## Design Review Board

October 10, 2018

# Lewis & Clark High School Addition

### Design Review Staff Report

## WEST ELEVATION

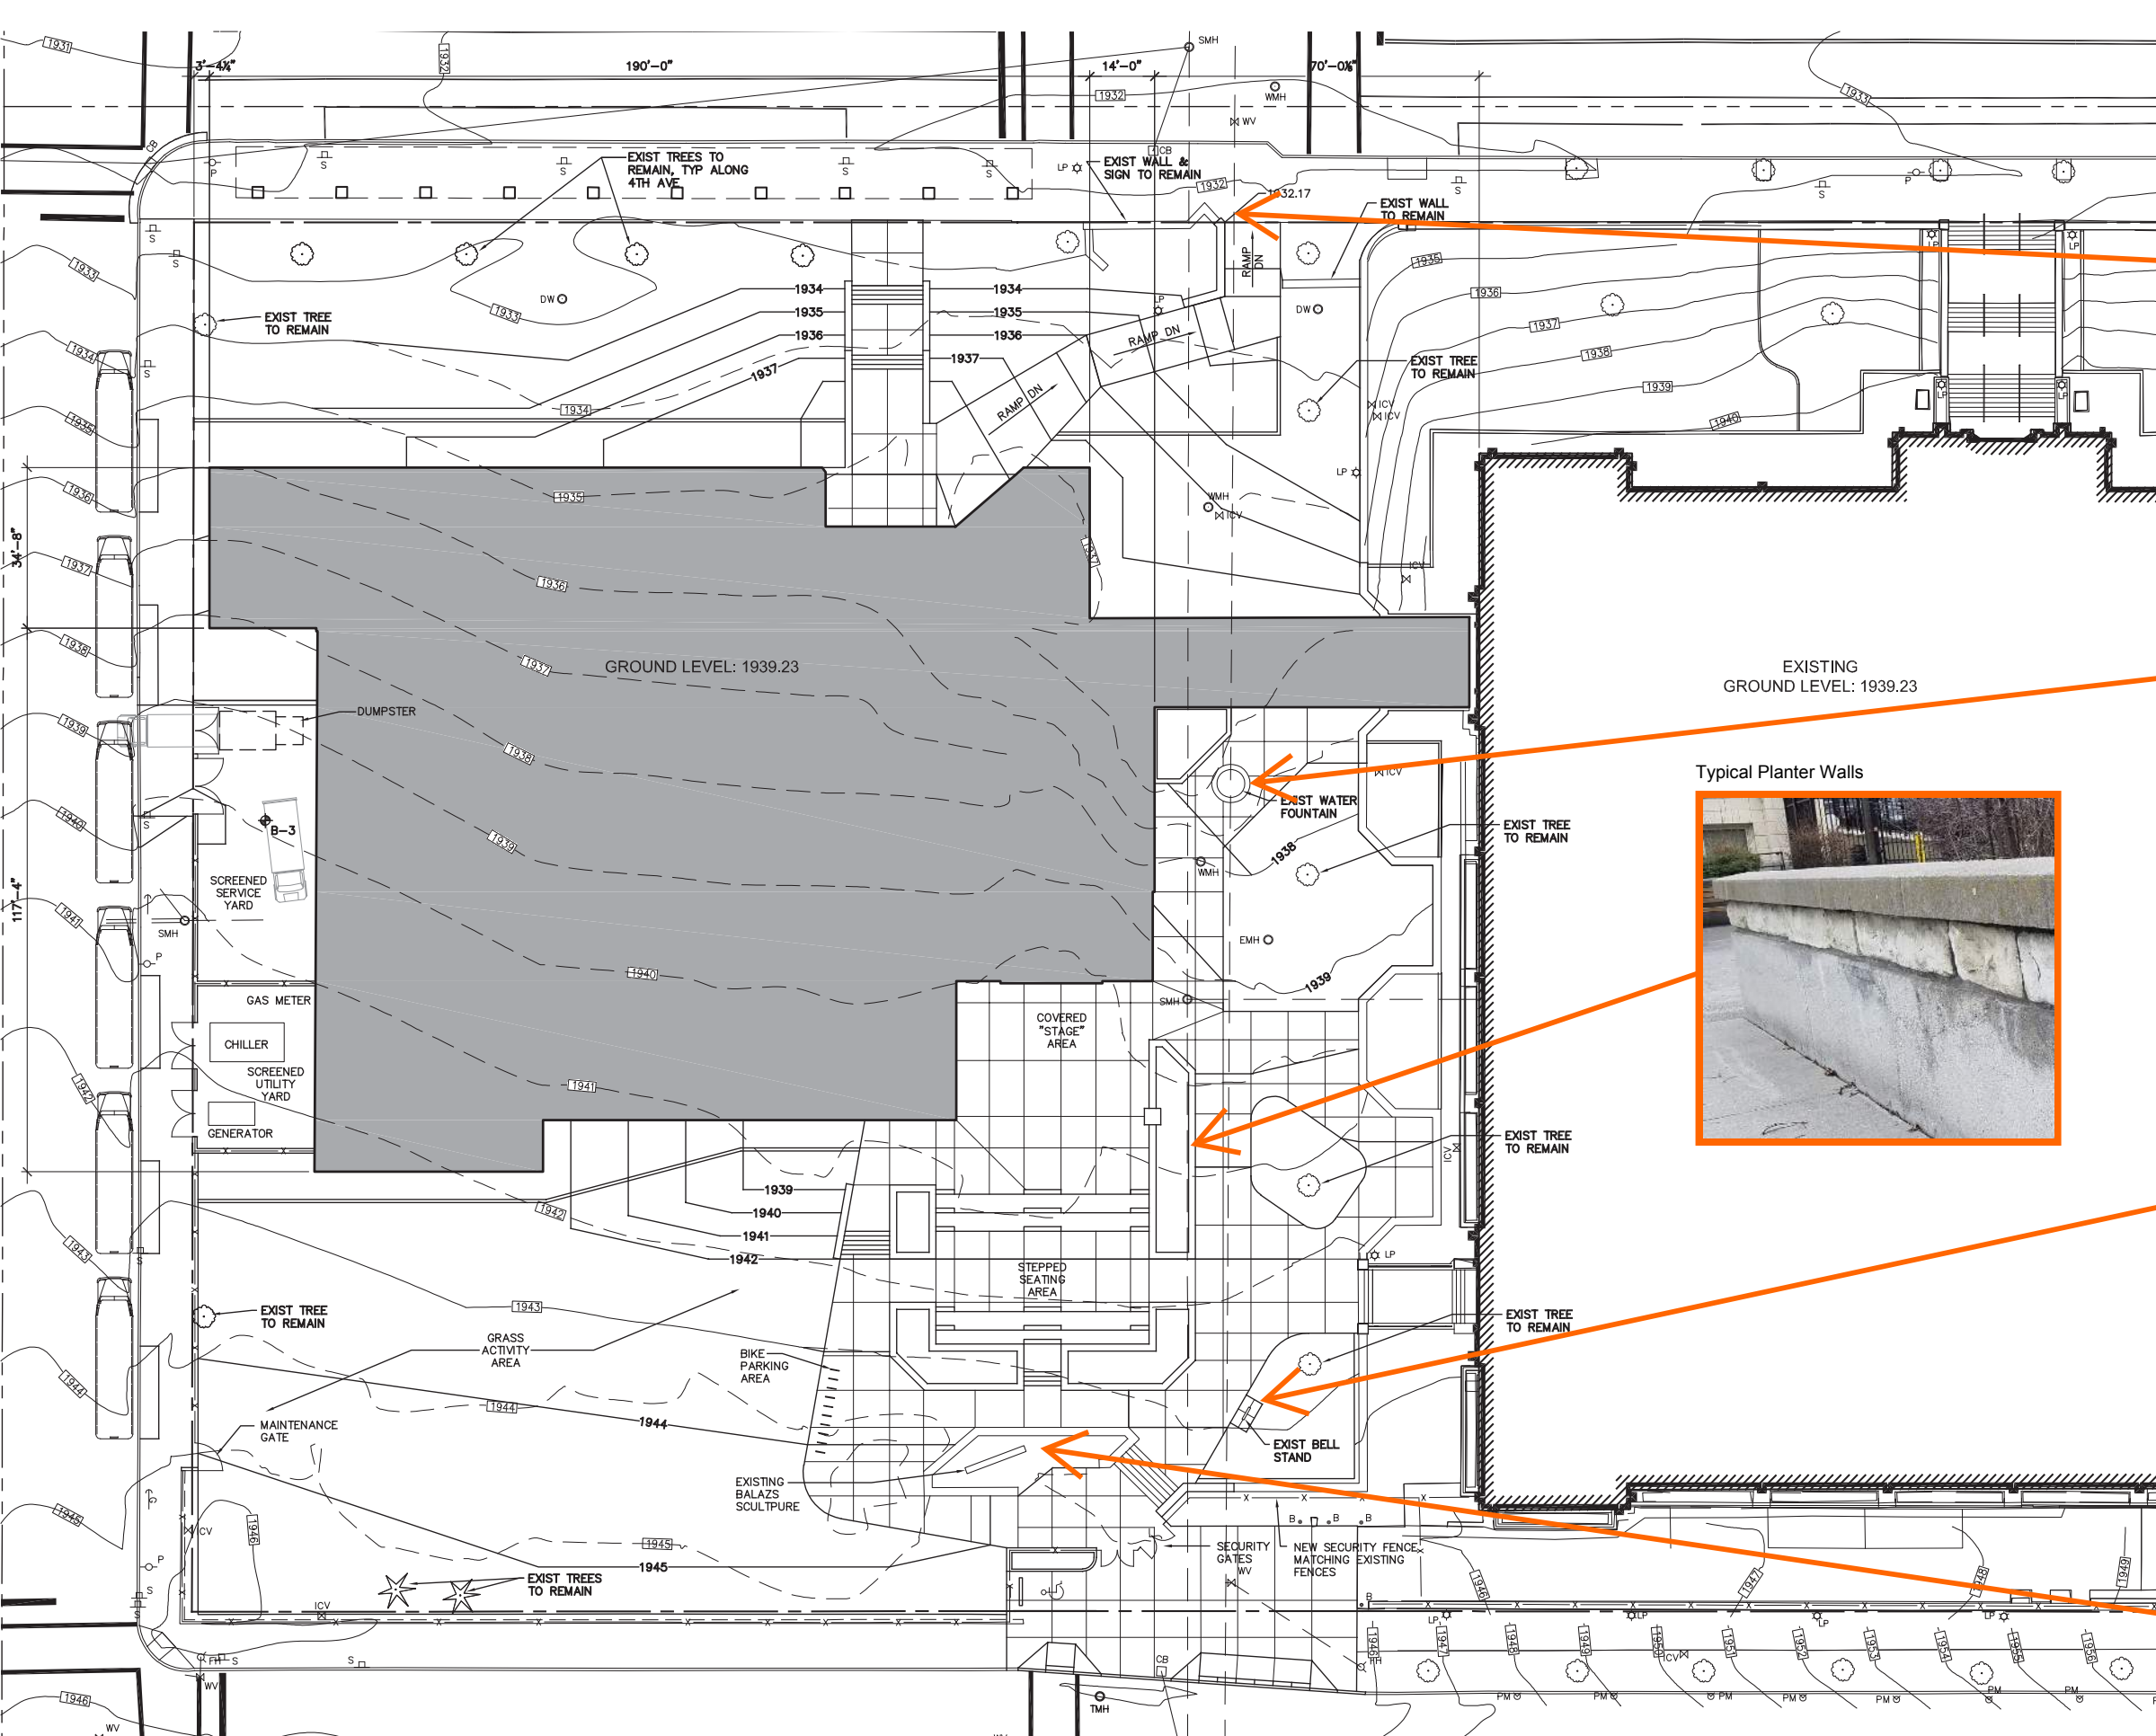
1. The applicant is encouraged to continue refining the building façades to ensure the building is “of its time” per the Secretary of the Interior’s Standards.

2. The applicant shall provide additional information regarding the configuration of all the building’s façades.

3. The applicant shall provide additional design information regarding masonry detailing.

5. The applicant has stated that the addition will have expressed columns (or pilasters); which reference the buttress pilasters on the historic main facility – a version of which can also be found on the field house addition (see applicant's submittal, page 3). The proposed pilasters will be expressed via a notch, or shadow line, within the brick facing on either side of the inset glazed/spandrel portions of the Fourth Avenue façade and will not stand proud of the plane of the facade. This is the same notched detail proposed for nearly every location of an inset fenestration; these other locations are not called out as "columns". Since this detail seems to be most strongly associated with the location of fenestration insets and not with any expressed columnation, is it fair to classify this treatment as a column or pilaster as proposed by the applicant? Is the need for columns on the front façade necessary to comport with advisory actions 1-3?

6. The applicant has proposed a series of operable awning windows in the front elevation's glazing units. This window type is not found either on the historic main facility nor the field house addition, though it is consistent with academic/institutional buildings constructed in the 1950's – 1970's. Is this window type consistent with advisory action 1 – that the addition be "of its time"?

*Details have been added that are modern interpretations of the existing historical building or parts of the 2000 field house addition. See attached elevations for additional information.*

*All the elevations have been developed. See attached elevations for additional information.*

*See attached elevations for additional information.*

**SITE AND GRADING PLAN**  
Scale: 1" = 40'-0"

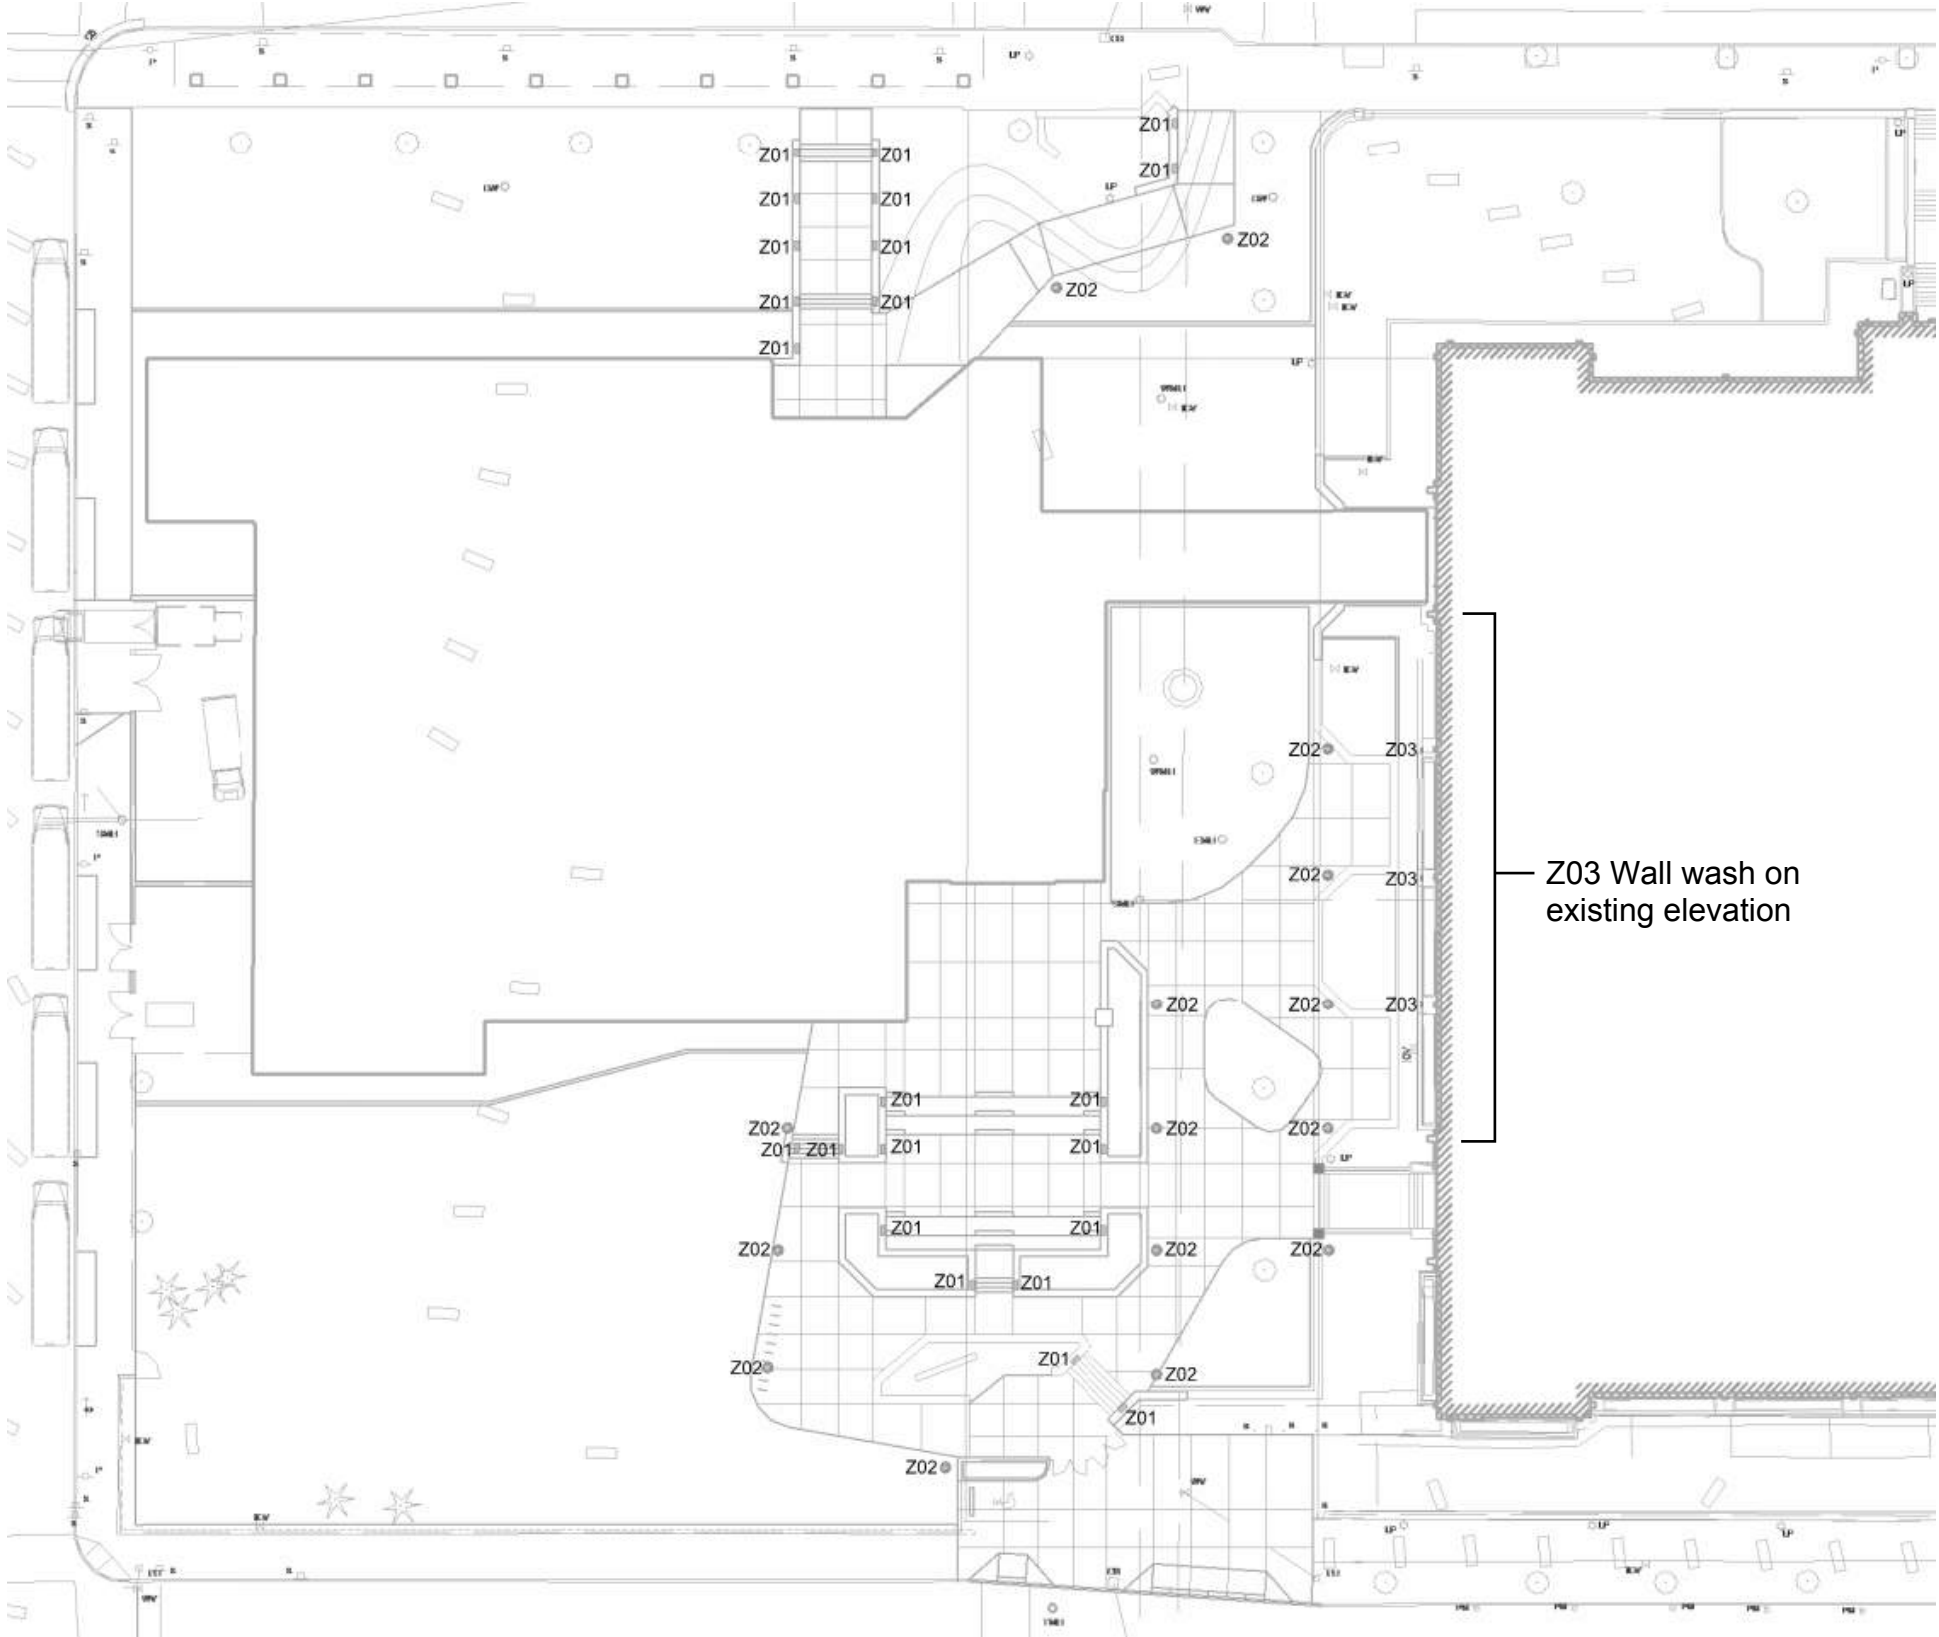
3. The layout for the site on the Lighting Plan is somewhat different than what is provided on the Site and Grading Plan and the Landscape Plan, but it does match the photorealistic illustration titled Outdoor Commons. Does the layout shown on the Site and Grading Plan and the Landscape Plan depict the correct plaza configuration?

4. The Site and Grading Plan indicates four existing site elements being preserved (4th Avenue Sign, Granite Fountain, Victory Bell Stand, and the Balazs Sculpture). There are a number of other memorial plaques placed on existing planter walls commemorating past graduating classes and teachers & people significant to the school's history. Has NAC catalogued these plaques, and are there plans to mount them on the new planter/retention walls in the new Outdoor Commons?

*The site grading and landscape plan are the most current version.*

*Yes the intent is to locate the many plaques in the new planter walls.*
